Executive Director's Recommendation

Commission Meeting: February 2, 2012

PROJECT**Intelligence Community Campus - Bethesda Master Plan**

Approval of final master plan

Figure 12: Current (proposed) garage placement alternative.

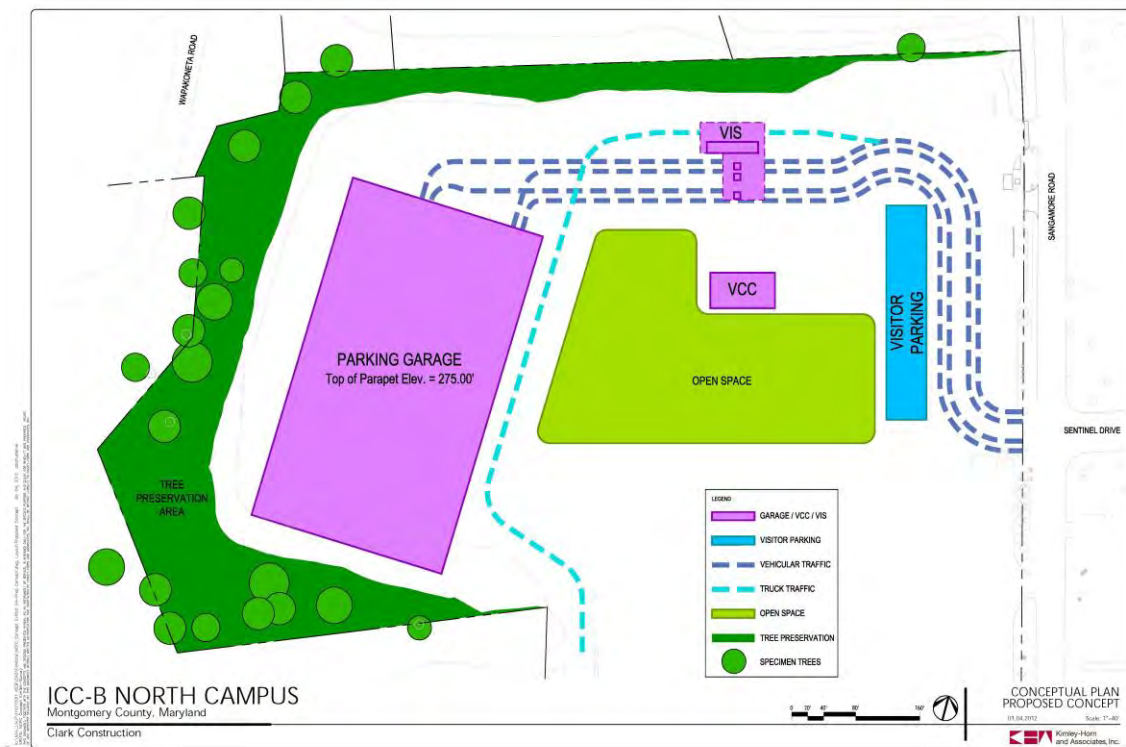
- Allows the Visitor Control Center to be placed the furthest distance and to have the least negative impact on views onto the site from Sangamore Road.

- Provides additional open space for screening at the north side of the site (adjacent to the Sangamore Local Park and Waldorf School).
- Does not require disturbance of underground bedrock.

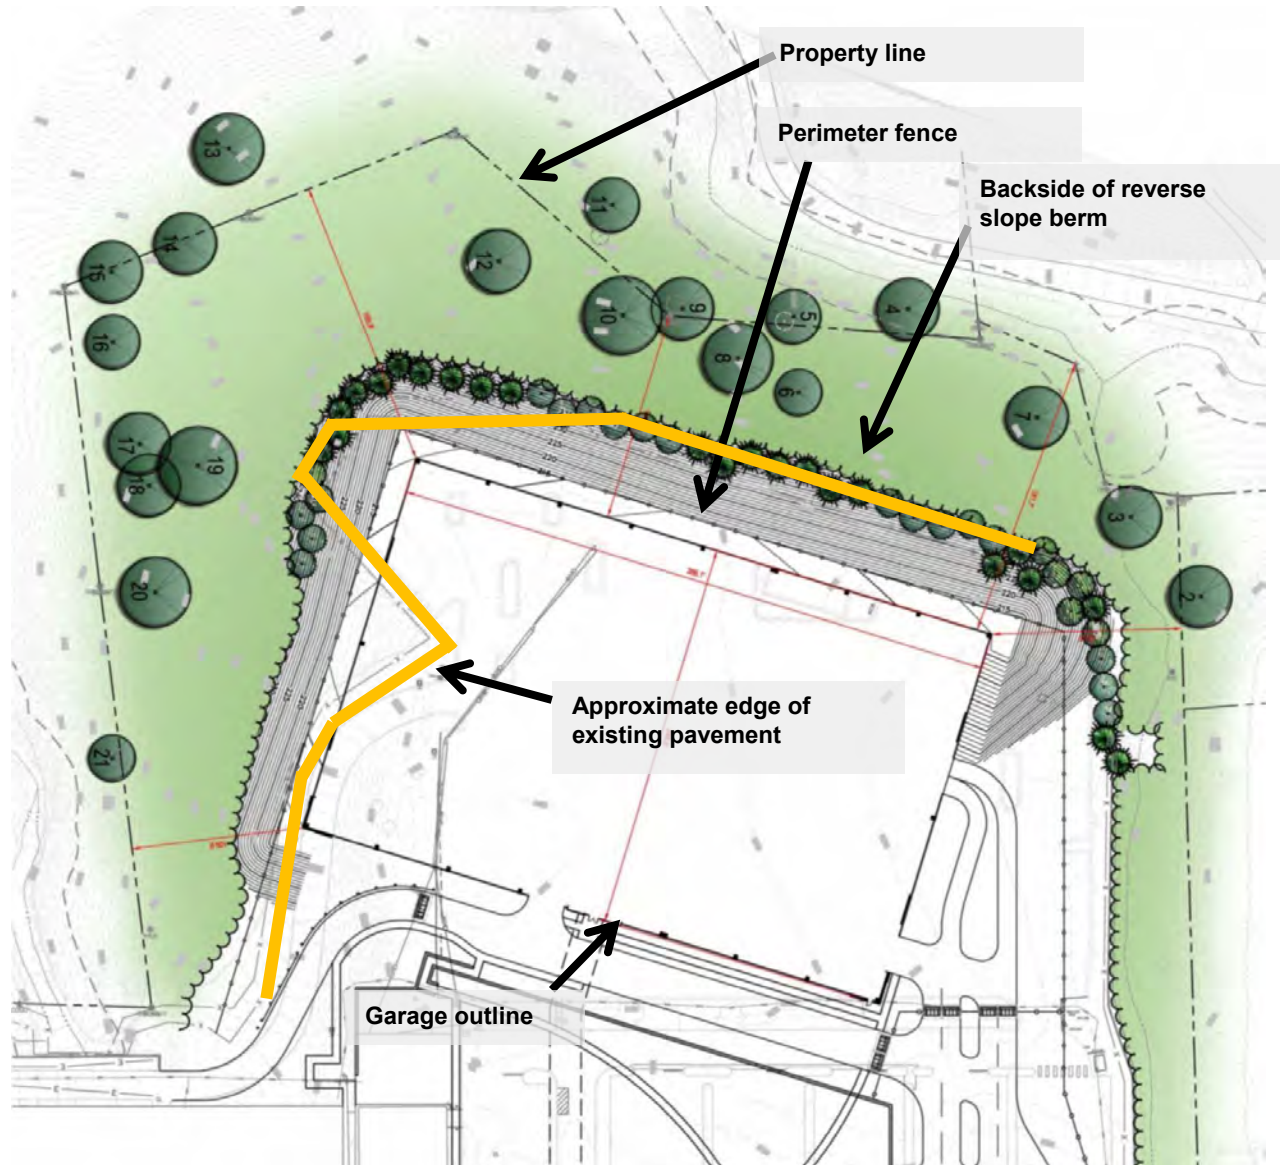
To further screen the garage and in addition to the previously proposed green screen on the sides of the garage, the USACE is proposing to add a screen of evergreen trees along the top of the reverse slope berm that when mature, will screen all but the top 5 to 10 feet of the garage.

Figure 17: Proposed garage site plan. The top of the reverse slope berm is proposed to be planted with a row of evergreens. The site's perimeter fence is pulled close (approximately 15 feet) to the garage with the clear zone between the fence and garage wall and upon the backside of the reverse slope berm. The edge of the existing pavement is roughly outlined by the orange line. Specimen trees are depicted as dark green circles; the current project proposal does not remove any specimen trees.
